IN THE DRAWINGS

FIG. 2

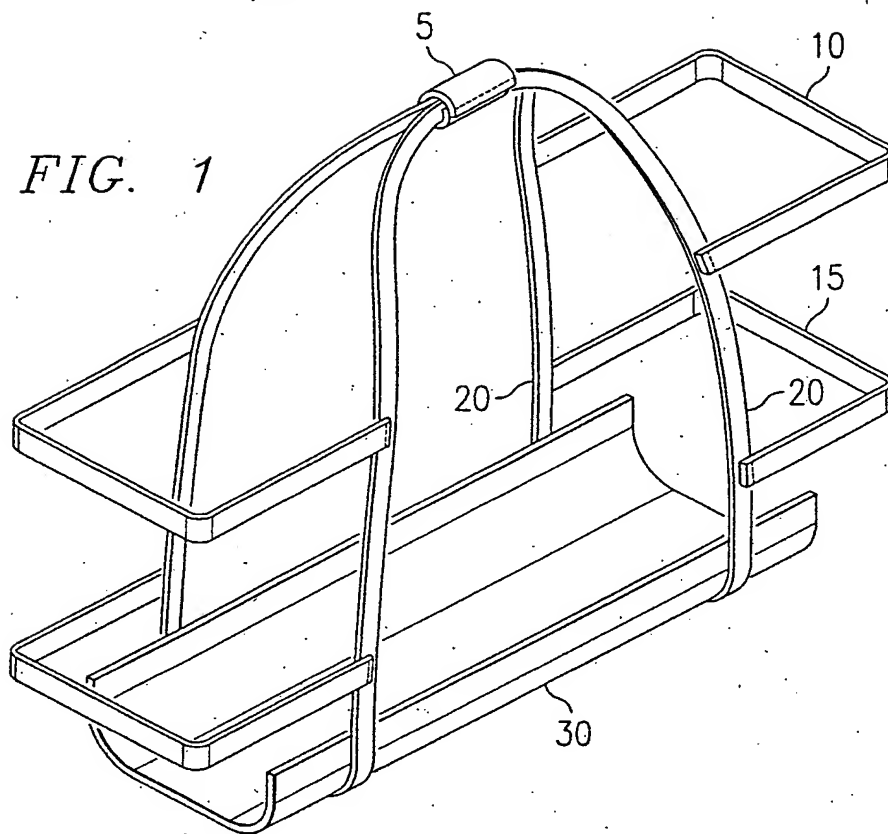
The drawings are objected to under 37 CFR 1.83(a). The examiner states that the drawings fail to show a means for adjusting the length of the carrying straps. The applicant respectfully submits that a proposed drawing correction is attached, wherein a length adjustment device 22 is clearly shown in Figure 2. The applicant respectfully submits that no new matter is added with this drawing correction, as a length adjustment device is identified on page 9, lines 12-13, and the first paragraph on page 10, as currently amended.

A redlined version of page 1 of the drawings is enclosed with corrections. A length adjustment device 22 is added to FIG. 2 at the top of each carrying strap 20.
